Ananta Huaxiang Ltd. (Extension)

222-223, H1, H2, H3, H4, Aepz, Narayanganj.
(23.677063, 90.523734)
13 September 2023

Observations

Fig: 3d Rendering View of shed.

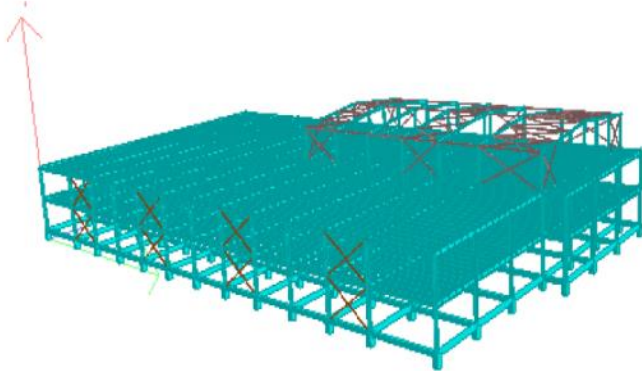
Inconsistencies in design report

Prayer room, RO room and walkway at roof level

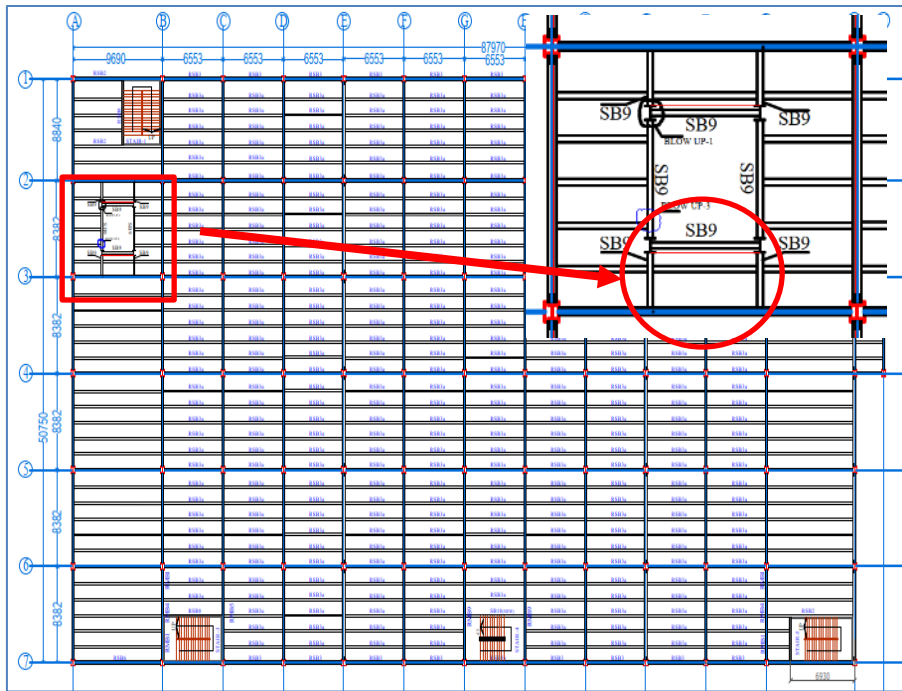
Prayer room, RO room and walkway not considered in analysis model

Load of Prayer room, RO room and walkway not considered in analysis model. Building engineer is required to update the analysis model as per onsite condition and update the design report accordingly.

Highlighted beam was shown in drawing

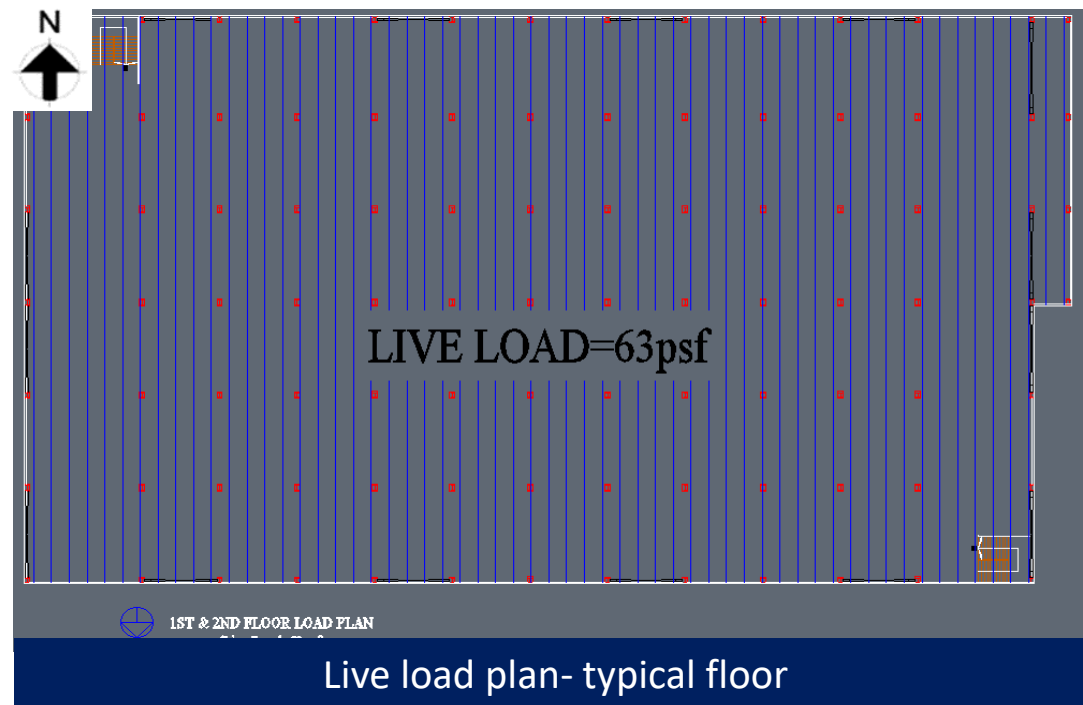
Highlighted beam was not found on site

Highlighted beam was shown in drawing but not found on site. Building engineer is required to update the as-built drawing, analysis model as per onsite condition and update the design report accordingly.
